Determination 2013/060

Regarding the refusal to issue a code compliance certificate for a 10-year-old house with a concrete tile roof at 209 Jowers Road, West Melton

Figure 1: Roof plan (not to scale)

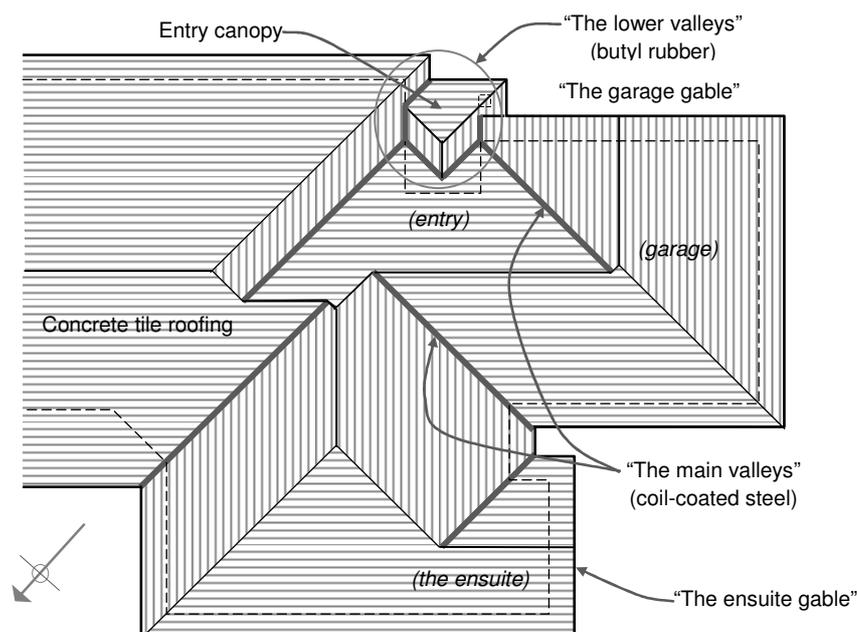
- 2.3 The 25° pitch hipped and gabled roof has eaves and verges of more than 600mm overall. The two gable ends include steel 'secret gutters' at the verges; concealed below metal barge flashings and intended to direct water into external gutters. The main valleys to the roof are coil-coated steel, which fall towards butyl rubber lower valleys above the entry as shown in Figure 1.

- there are five junctions where valleys meet ridges (refer Figure 1); and mortar has been carried onto the gutter lining as bird proofing in lieu of mesh, which is reported by roofers to be a common practice
- cement plaster and coil-coated steel are noted in Tables 21 and 22 of E2/AS1 as compatible in both contact and water flow
- the metal valley gutters have been in place for 10 years with no apparent problems and are required to achieve a 15 year minimum durability
- although not noted by the authority, mortar also carries onto membrane valley linings and constricts the valley width.

- the lower valley gutters above the entry canopy, in respect of:
 - the inadequate membrane gutters
 - the slope of the north lower gutter
 - the width restriction imposed by the mortar
 - the exposed timber
 - the heavy moss growth in the gutters
- the inadequate and undersized secret gutters to the ensuite and garage gable ends, resulting in the water penetration into the ensuite soffit

- 10.1 A notice to fix should be issued that requires the owners to bring the house into compliance with the Building Code, including the defects identified in paragraph 6.1.1, but not specifying how those defects are to be fixed. It is not for the notice to fix to specify how the defects are to be remedied and the building brought to compliance with the Building Code. That is a matter for the owners to propose and for the authority to accept or reject.
